A7. POST-APPLICATION DISCUSSION

COMMENTS BY THE PRIMROSE HILL CONSERVATION AREA ADVISORY COMMITTEE

Primrose Hill Primary School Princess Road NW1 8JL Listed Building PRE-APP

LB PLANNING AND CONSERVATION

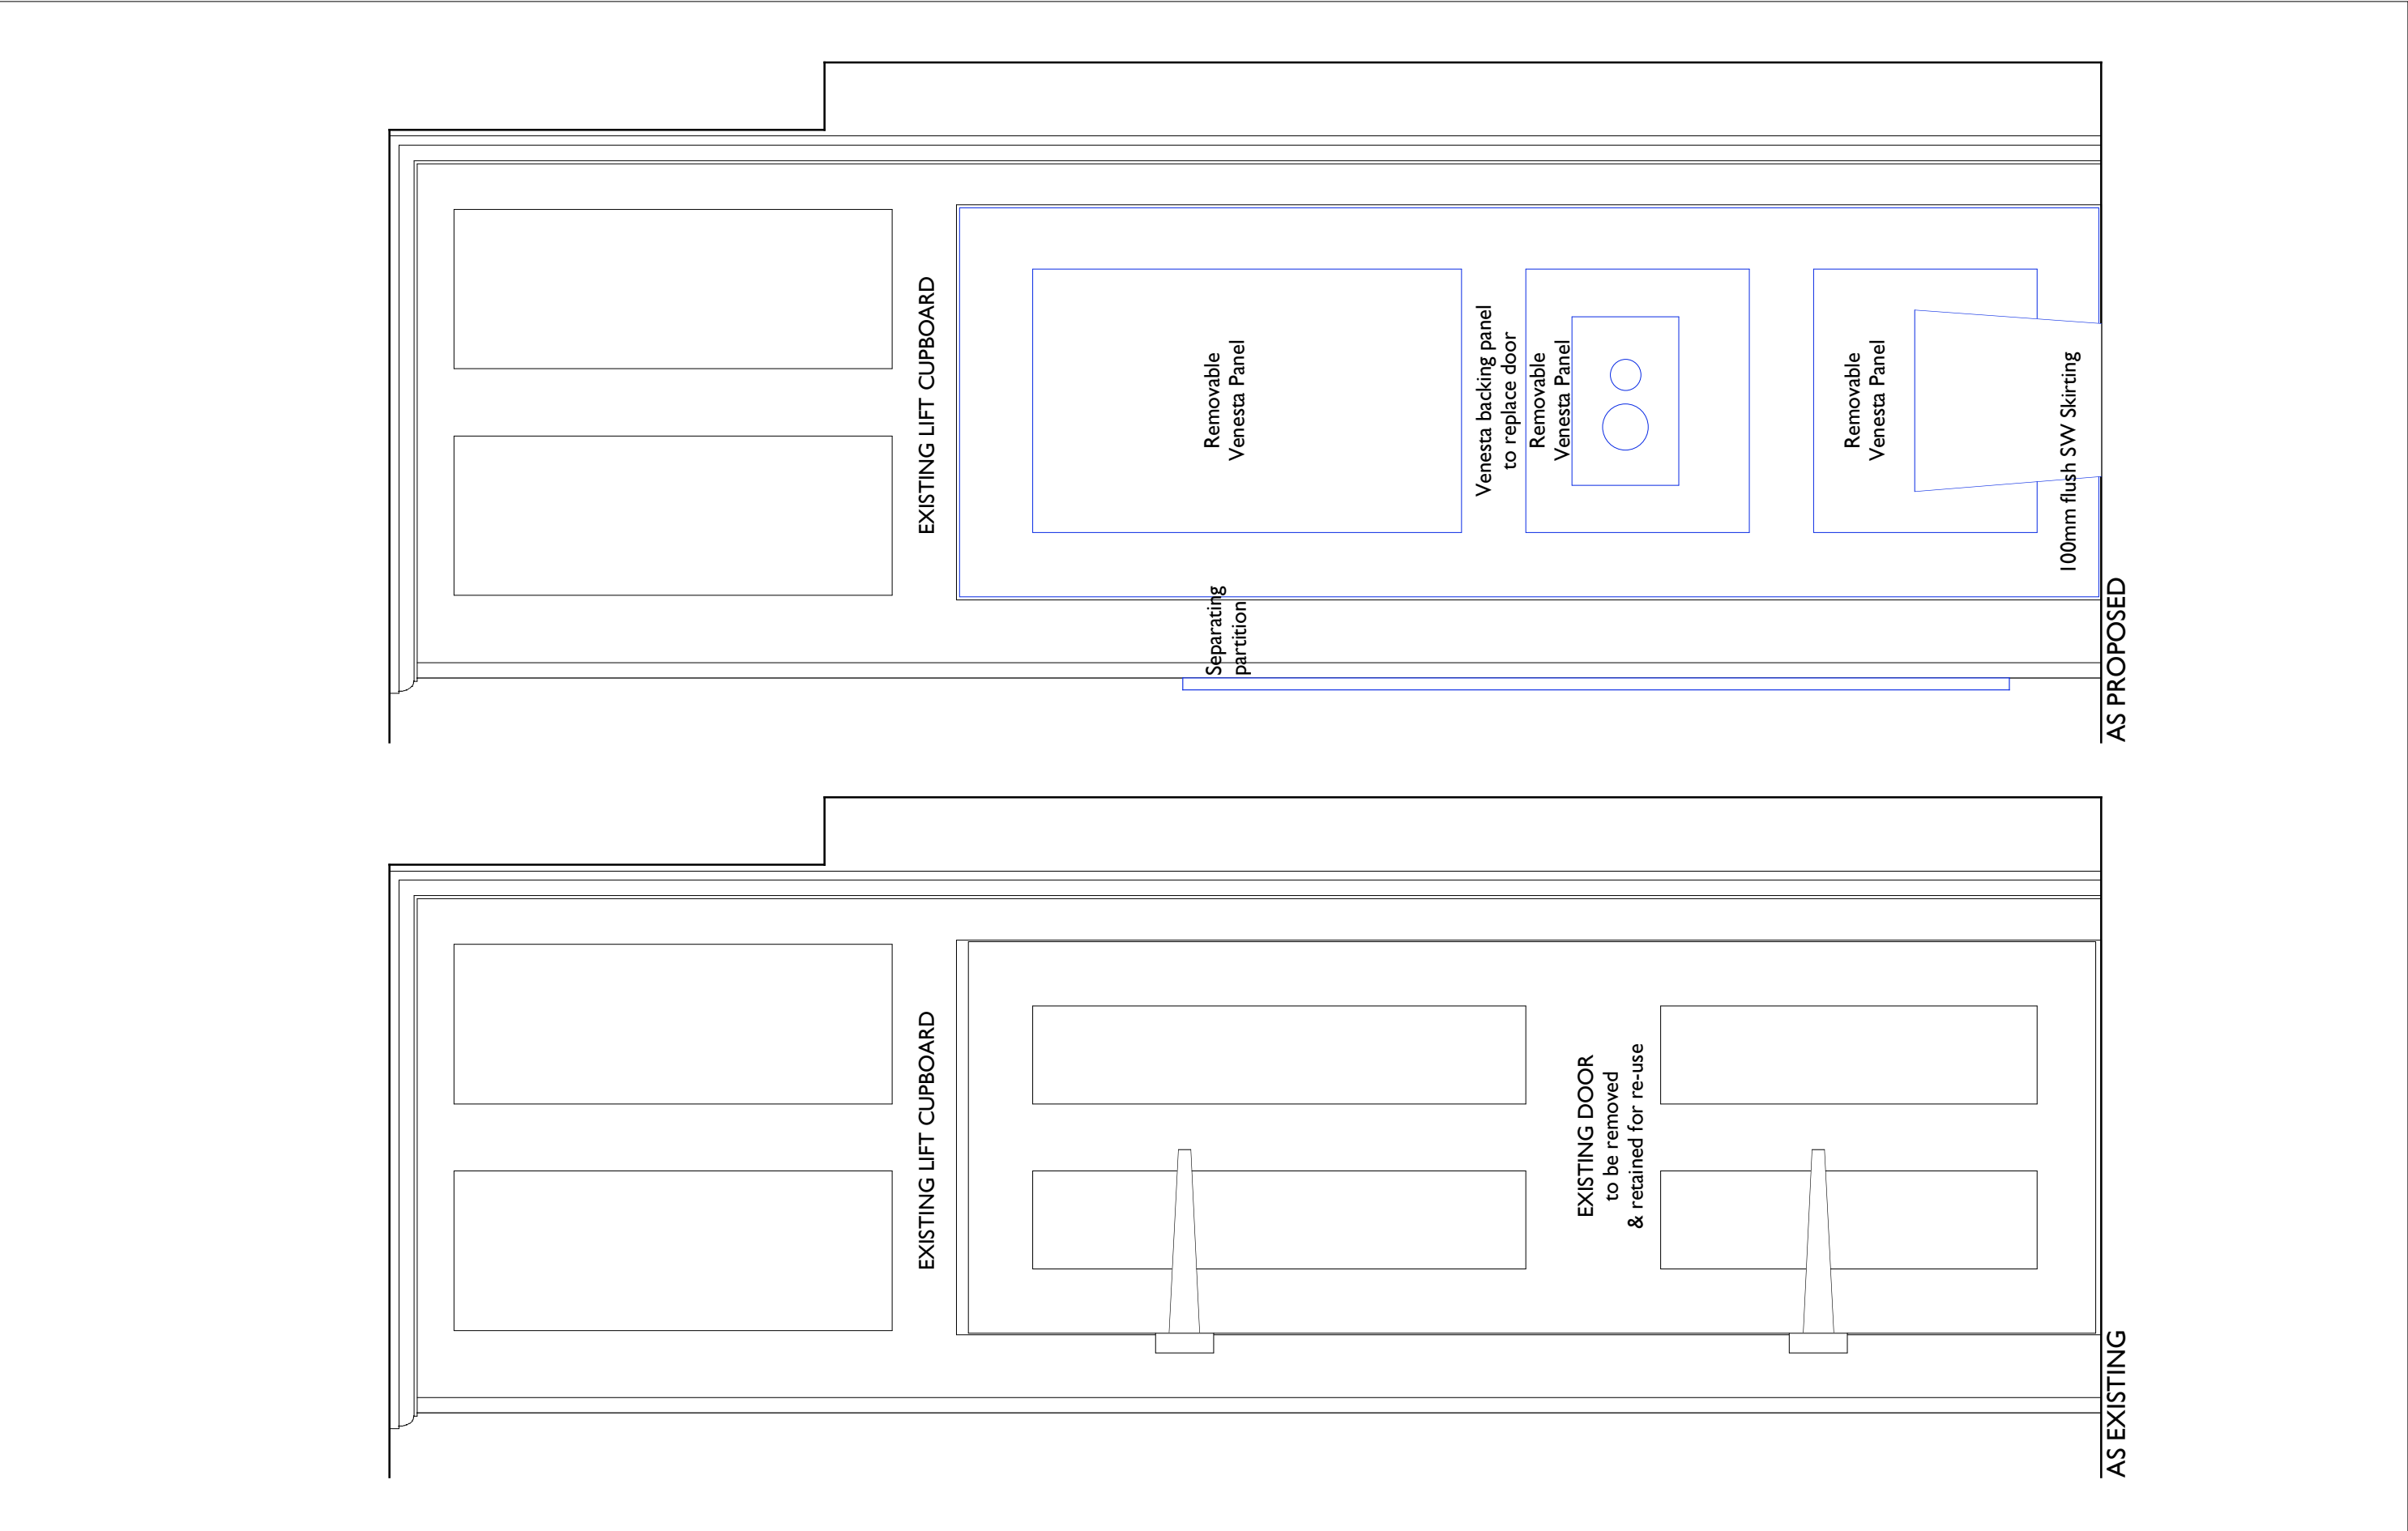
5. LBC will resist removal of the original lift housing/ current cupboard in Reception WCs. RL to assess effect of floor area loss if WCs are moved to side.

Response: Revised proposals are attached below showing the original lift cupboard to be retained with the non-original door replaced by access panels and a new WC to be located in front. The adjacent door and frame to the cupboard under the stairs is reversed. Drawings attached below: PRPS PR 332_G and PRPS PR 512_G.

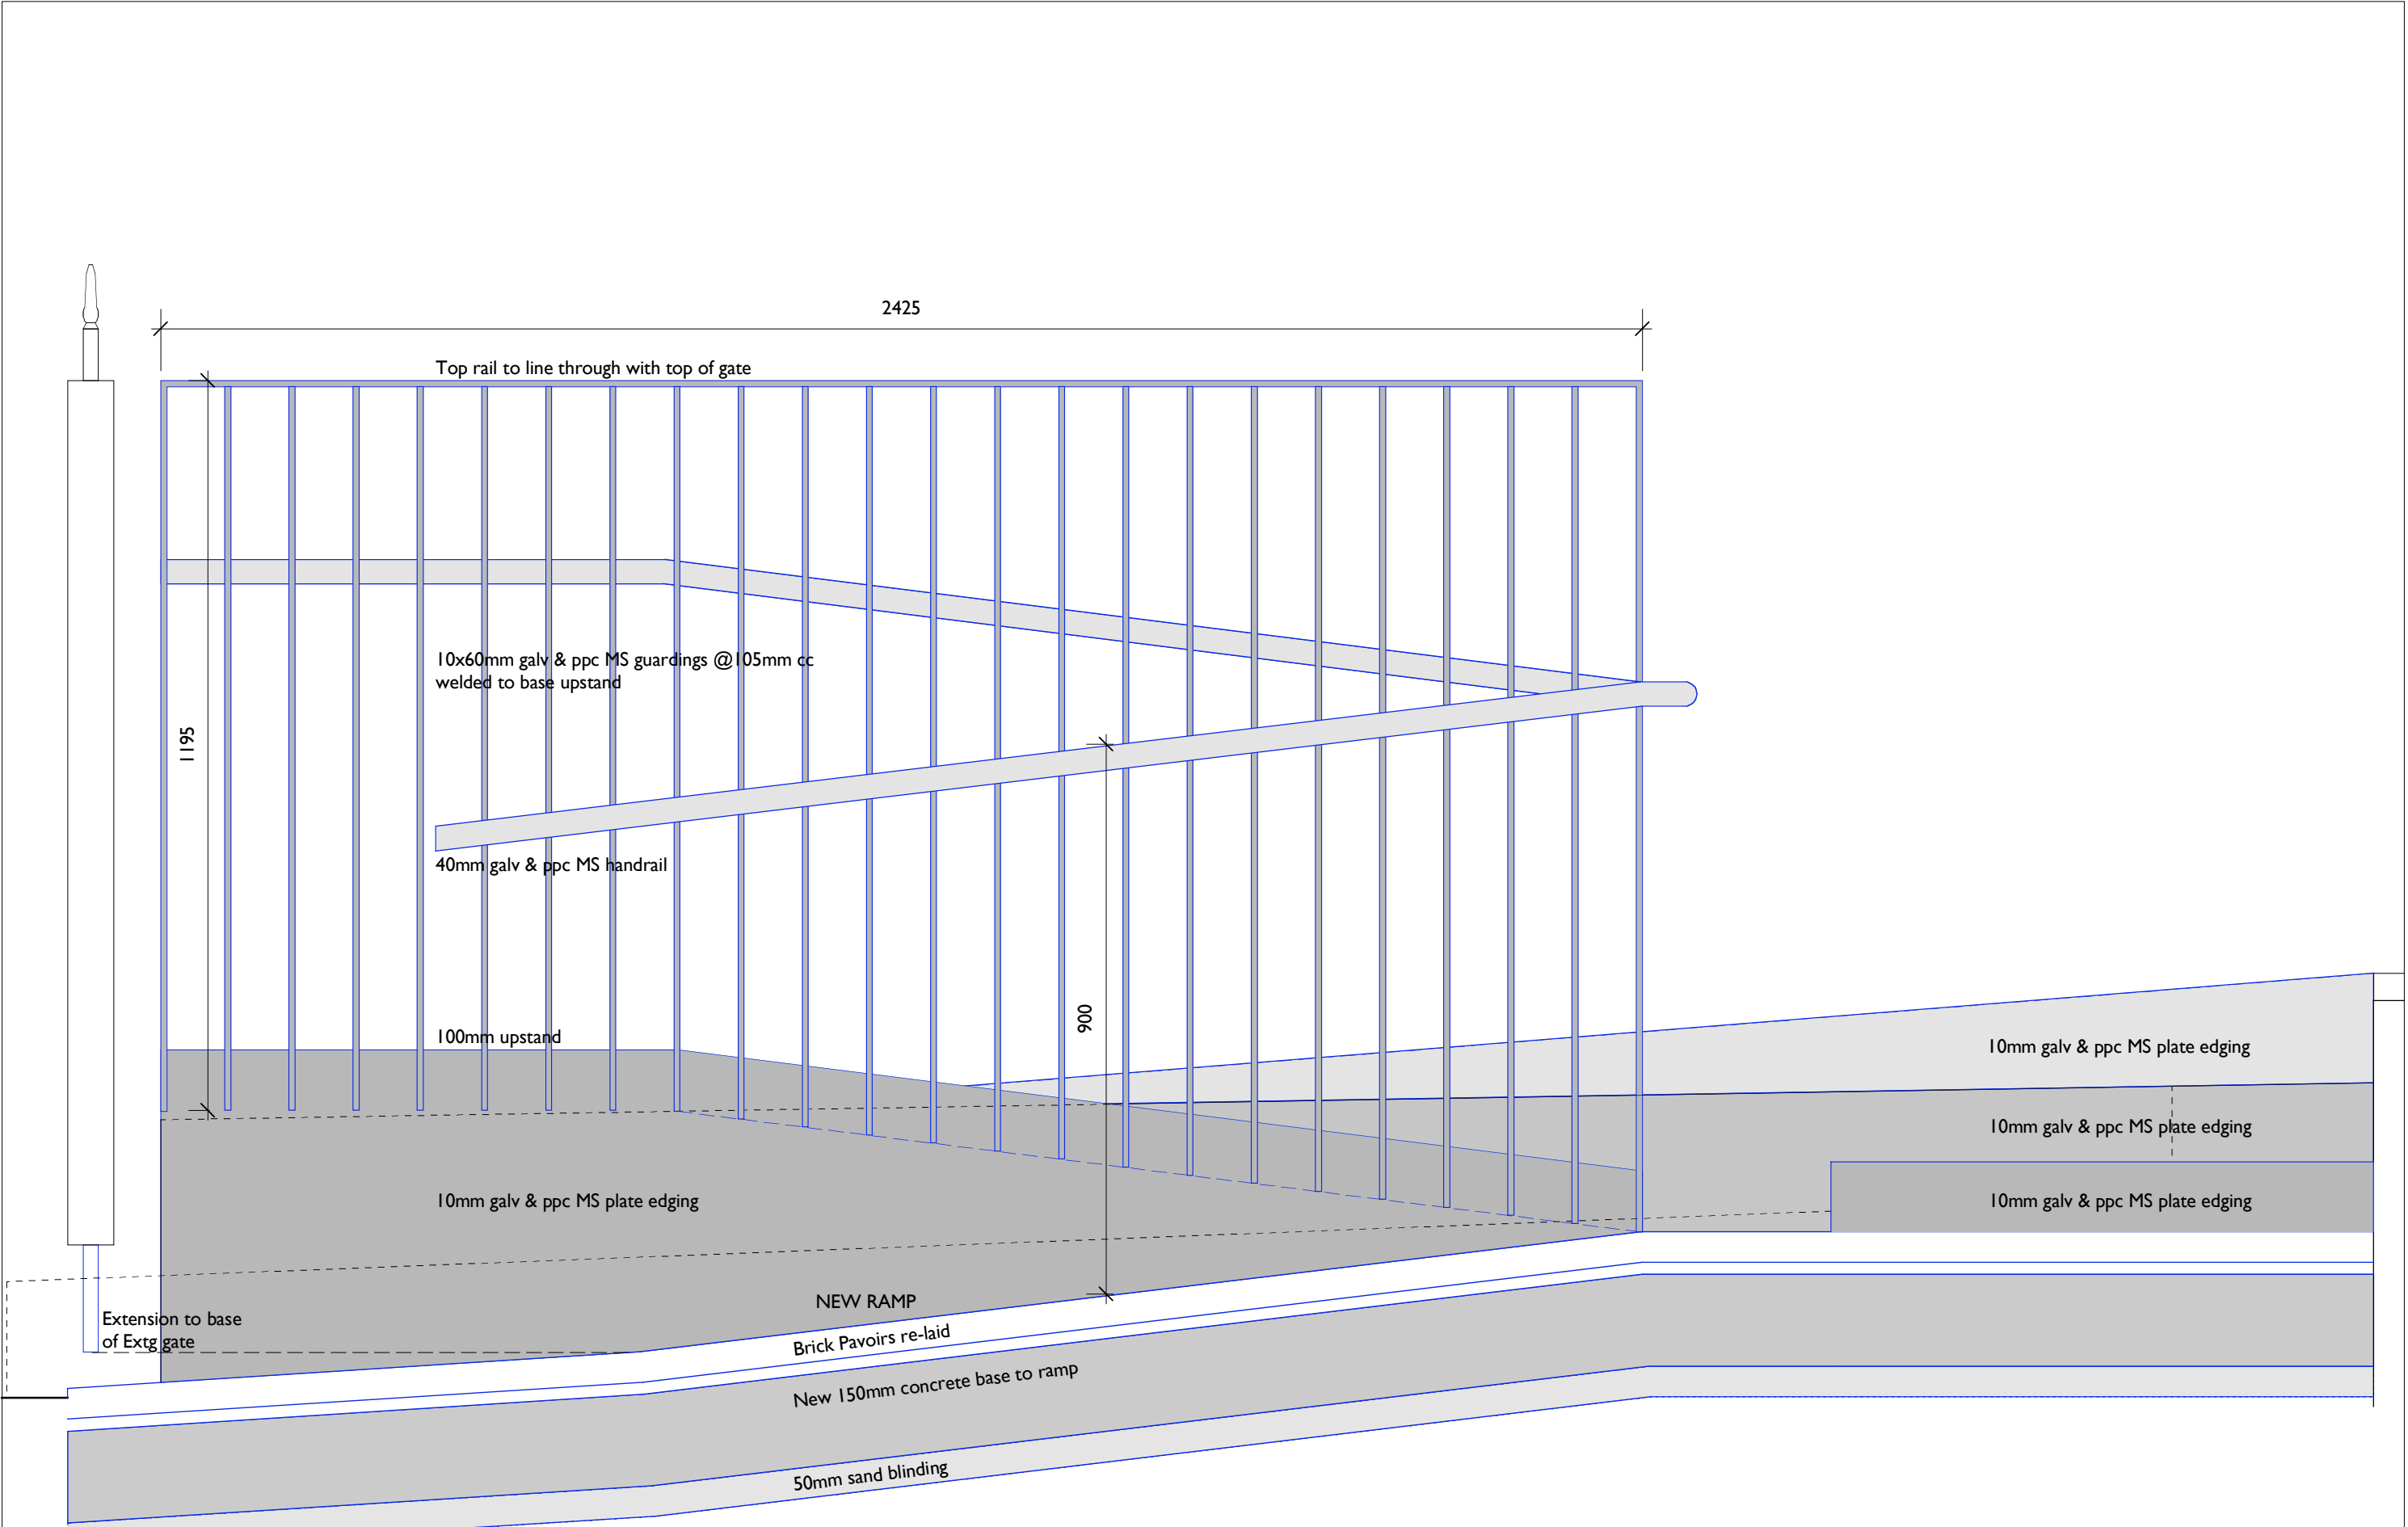
15. Details of gate alterations, ramp and railing at the front of Caretaker’s House to be provided.

Response: A 1:10 detail on entrance gate alterations at the front of the Caretaker’s House is attached below: PRPS 350_G, PRPS PR 520_G and PRPS PR 521_G. A section through the ramp with elevation of the new internal guarding is shown in PRPS PR 522_G.
